**ACTION TRANSMITTAL No. 2014-22**

**SUBJECT:** Scope Change Request for the Crystal Lake Regional Trail in Robbinsdale  
**REQUESTED ACTION:** Three Rivers Park District requests a scope change to modify the scope of SP#091-090-075 to increase the length by 0.4 miles, change the trail alignment, eliminate three bridges, change approximately 0.5 miles of the project from off-road trail to on-street facility with shared lane markings, and move the regional trail head facilities. The change would reduce the budget to a total of \$2,600,000 with \$1,840,000 in Surface Transportation Program (STP) funds (less than the \$2,163,200 originally programmed) and an increased local amount of \$760,000.

**SUBJECT: CRYSTAL LAKE REGIONAL TRAIL- ROBBINSDALE SEGMENT, ROBBINSDALE,  
MINNESOTA – SCOPE CHANGE REQUEST**

**Subject:** Crystal Lake Regional Trail (Robbinsdale Segment)  
Additional Information for Amendment Request  
SP# 091-090-075

CSAH 81  
STA. 1057+50.00 - 1059+00.00

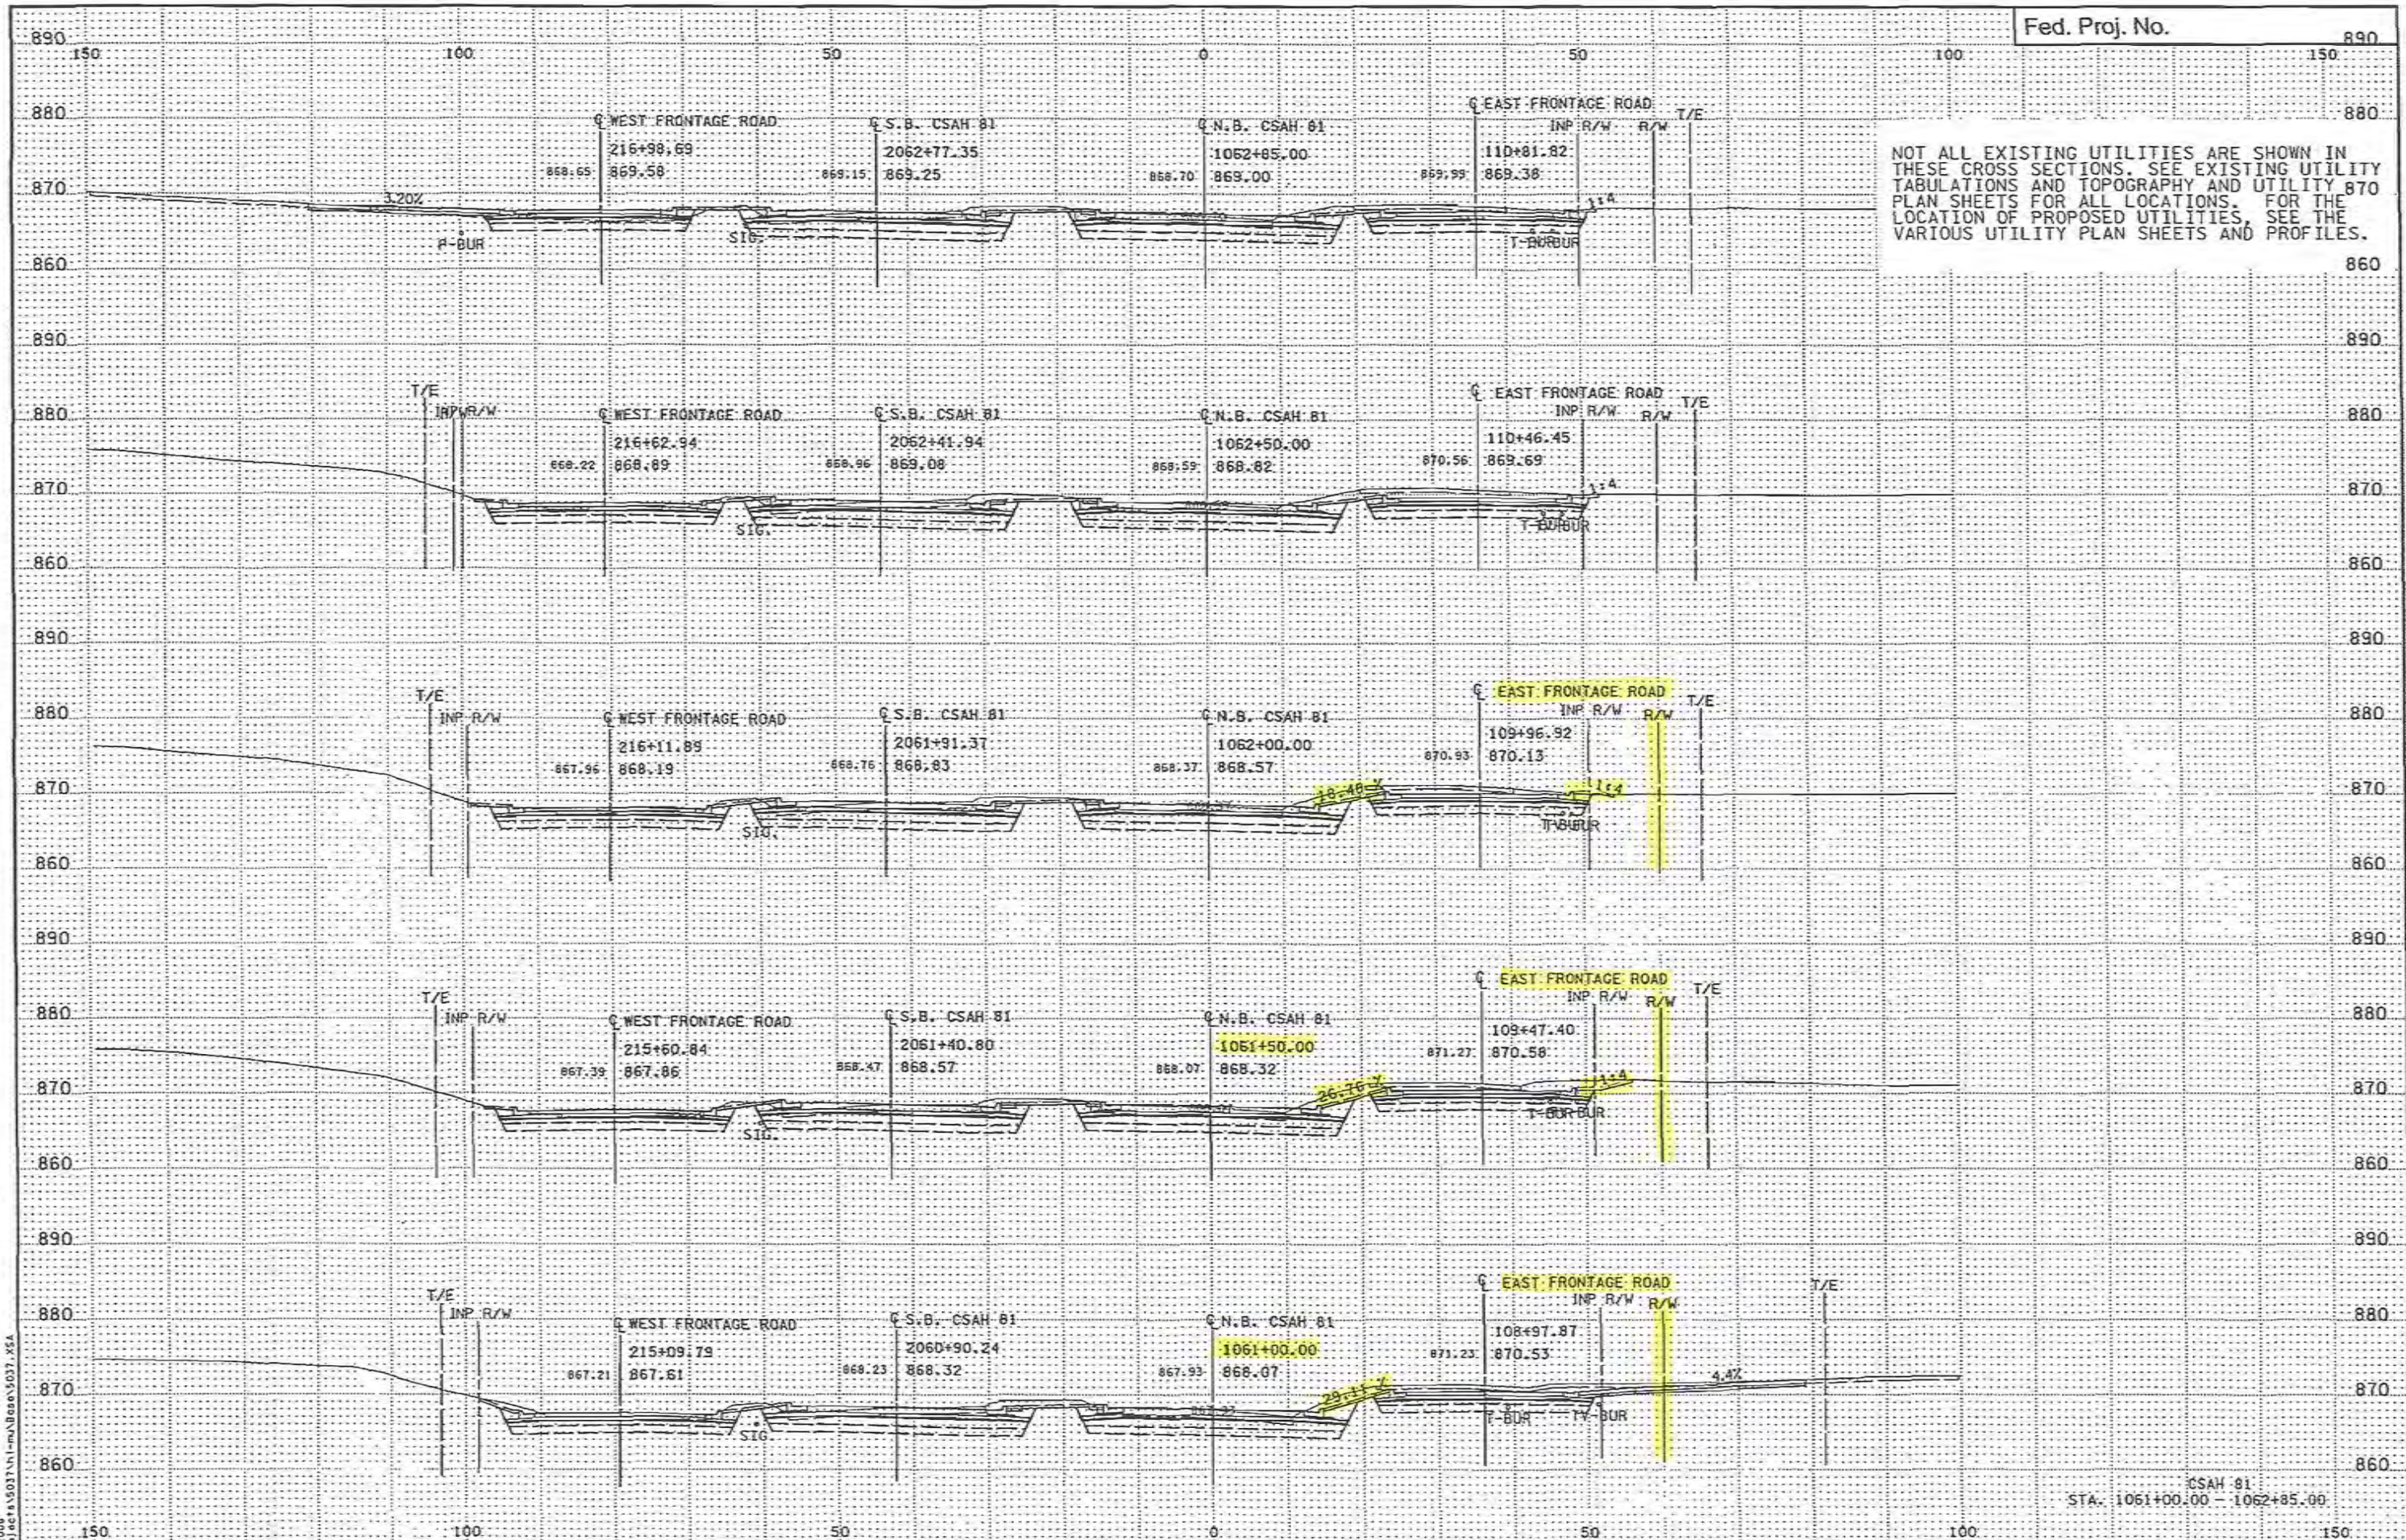
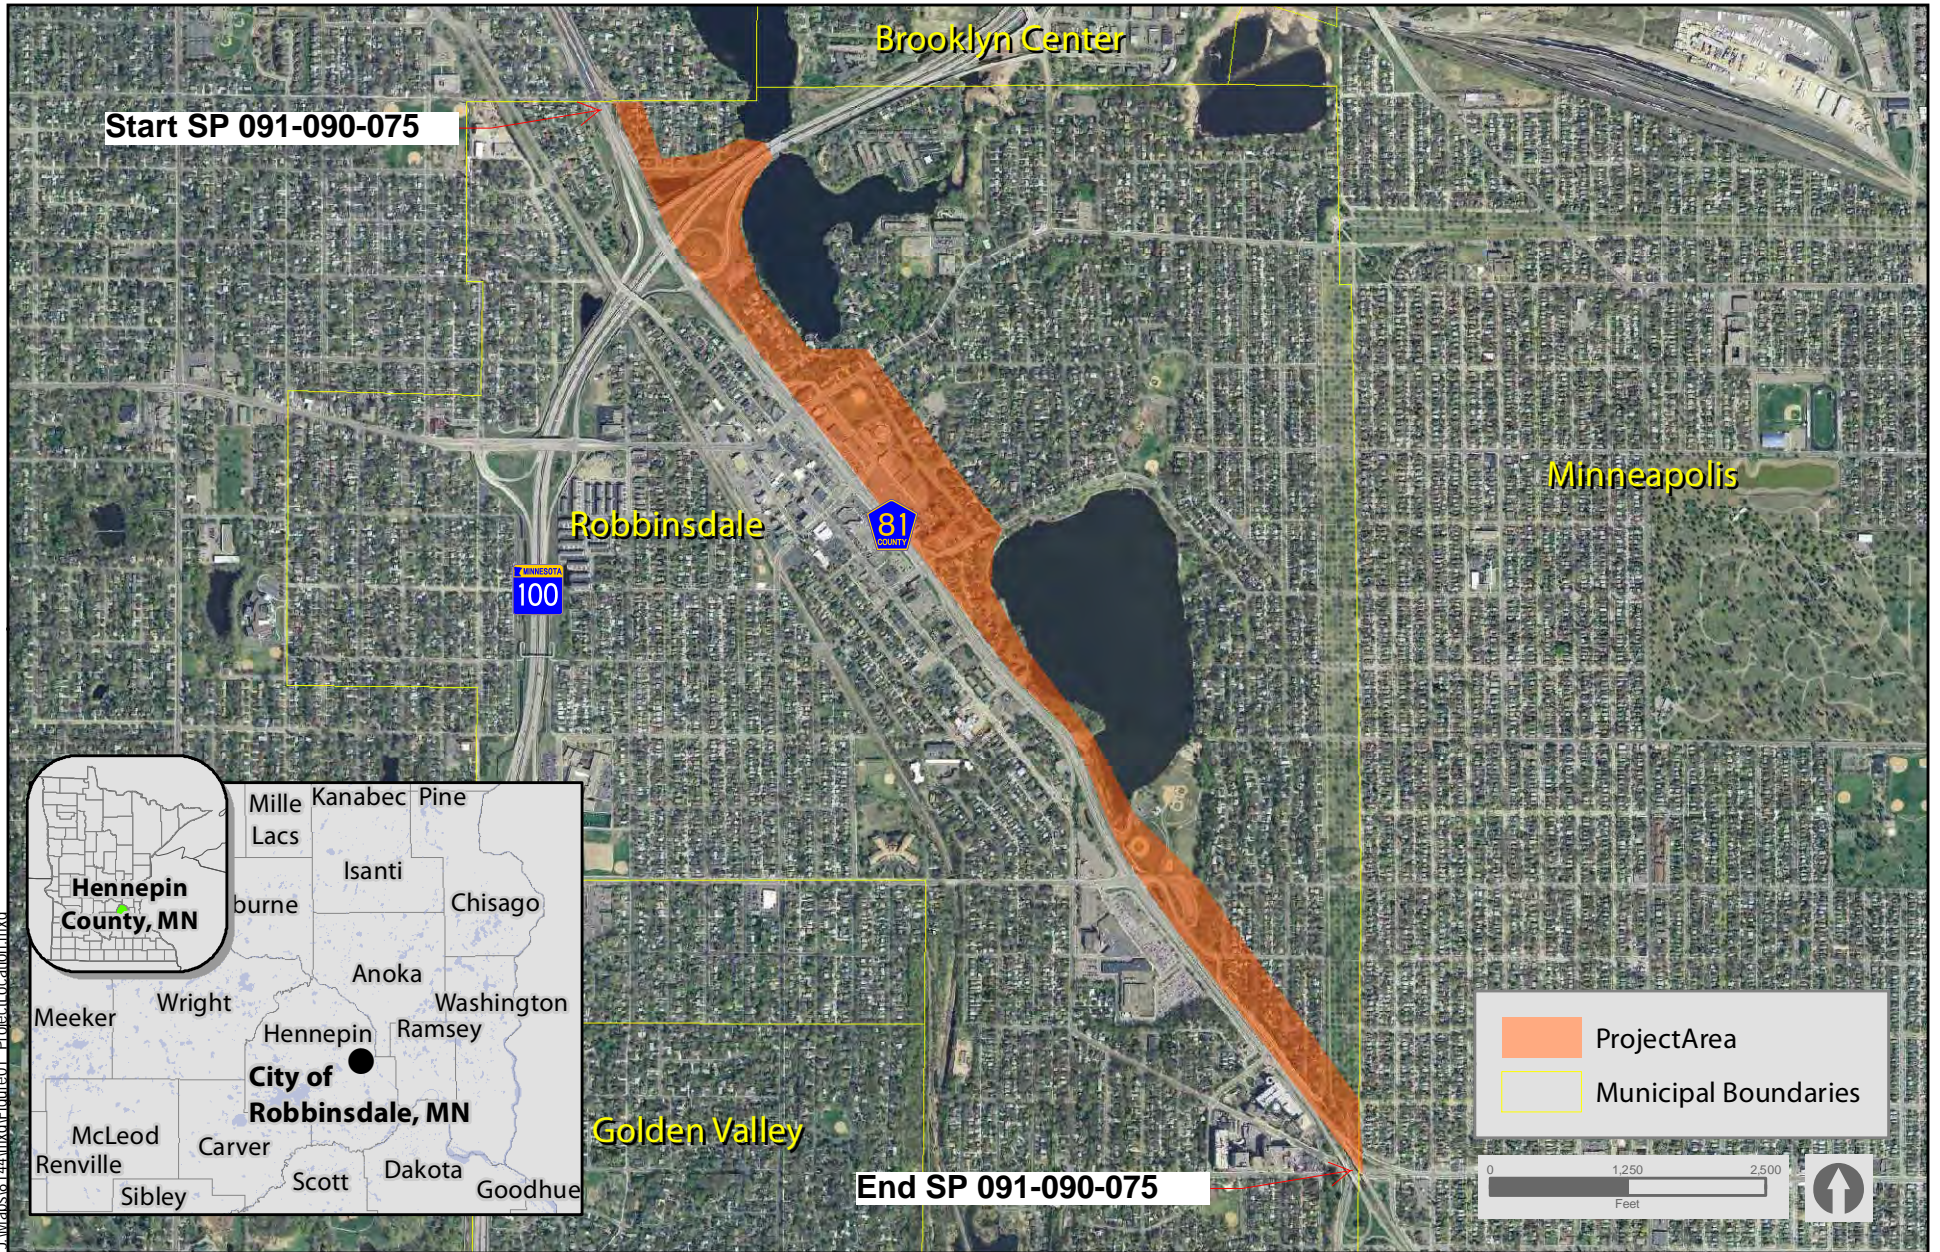
- Cross Sections from the CSAH 81 Reconstruction Project (Sheets 660-662 of 713) – Note the significant walls, trees and slopes in the boulevard of the East Frontage Road as well as the steep slope between CSAH 81 and the East Frontage Road
